From: Amanda Scholes on behalf of Planning.Responses
Sent: 10 November 2021 08:32
To: Planning Scanning
Subject: FW: Y/123/21/PL - Land to the south of Ford Lane and East of North End Road, Yapton
Attachments: A958_01E_PLANNING LAYOUT COLOUR NO SCHEDULE.pdf; A958_01E_PLANNING LAYOUT NO SCHEDULE.pdf
Importance: High

Project:
FORD LANE, YAPTON (SOUTHERN
PARCEL)

Title:
PLANNING LAYOUT

Job No.	Drg No.	Rev.
A 958	01	E

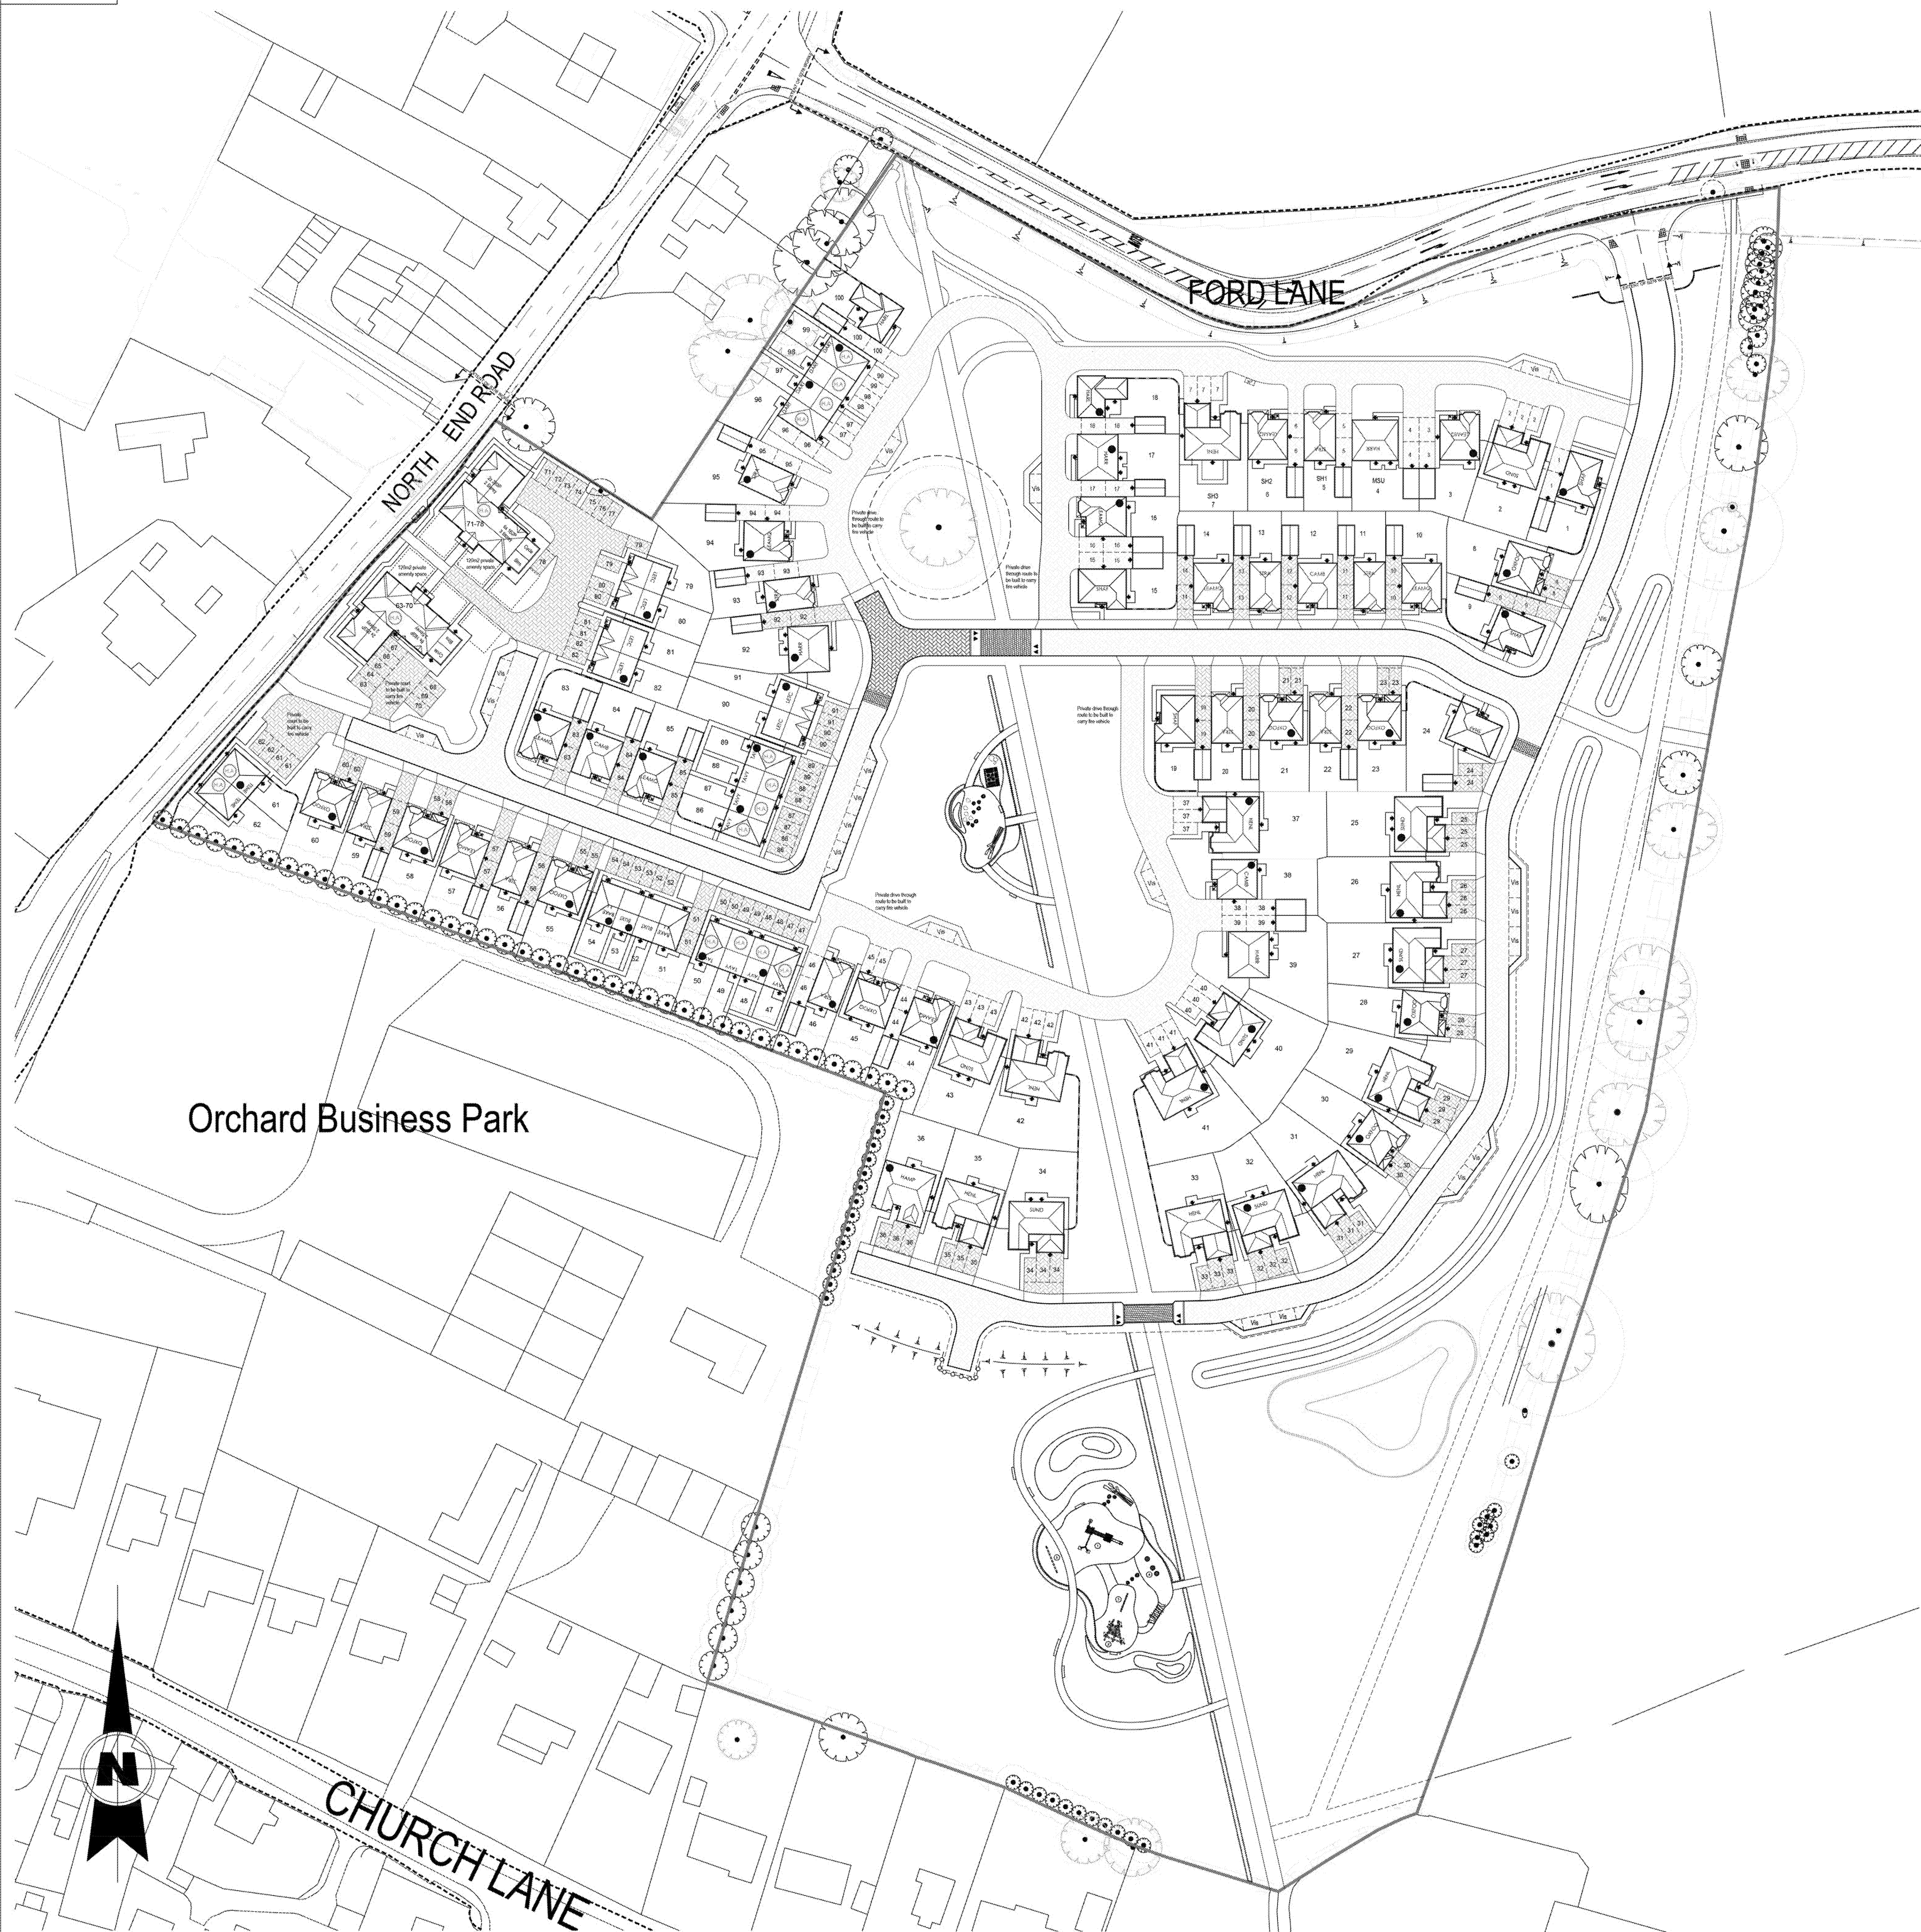
To protect this area would appear a sensible option and fencing could be used to tie in with the bunding to the east and west to help prevent unauthorised access onto the POS.

The alternative to this and **my recommendation would be just to extend the bunding in the same location as the shown fencing** (fencing can be chain sawed off at ground level so bunding would be potentially a more secure option) bunding when seeded would be less obtrusive and would tie in with the already proposed bund as shown.

Either would work assuming access not required for maintenance machinery off the turning head when in fact a gate would then be required rather than just post and rail fencing?
